Environmental  
Protection Agency

August 17, 2011

RE: CUYAHOGA COUNTY  
CITY OF CLEVELAND  
I-90 INNERBELT PROJECT  
NPDES PERMIT NO. OHC000003  
OHIO EPA PERMIT NO. 3GC04733\*AG  
CONSTRUCTION STORM WATER

Figure 7. Unprotected catch basin with Pier 7 dewatering directly into it.

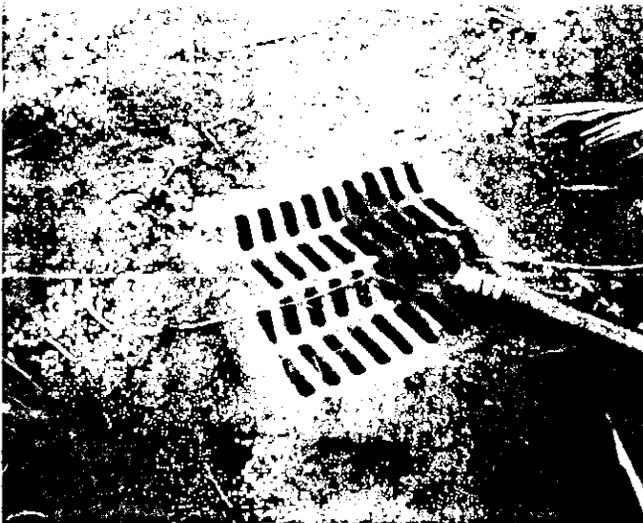
- ***There are storm sewer catch basins with inadequate inlet protection or no inlet protection at all.*** The catch basin by Pier 8 had a compost filter sock wrapped around it. The filter sock is not an appropriate form of inlet protection, and must be replaced by acceptable inlet protection as specified in the SWP3 (i.e. Dandy Bags, Silt Sacks, etc.). In addition, inlet protection #IP-11 was not installed at all. Please install inlet protection as specified in the SWP3 immediately (See Figure 6 & 7).

- ***Controls must be installed to prevent sediment-laden discharges from dewatering activities at pier excavations.*** During the visit, ground water from the Pier 7 pit excavation was being pumped to an unprotected catch basin. The discharge appeared clear at the time of inspection; however, it was apparent that water that collects within pier excavations can be sediment-laden after a rain event. Although we noted the presence of a dewatering bag on site, it was not in use nor situated correctly at the time of inspection. Dewatering bags must be located on stabilized ground with no potential for treated water to re-accumulate sediment after discharging from the bag and before entering the catch basin (See Figure 7). Other acceptable methods for dewatering include pumping to a sediment pond or dewatering through a sump consisting of a perforated standpipe wrapped in geotextile and embedded in stone after allowing at least 24 hours for sediment to settle (see Enclosure). We noted the presence of sumps within the pier excavations, but it was not evident that they had been wrapped in geotextile.
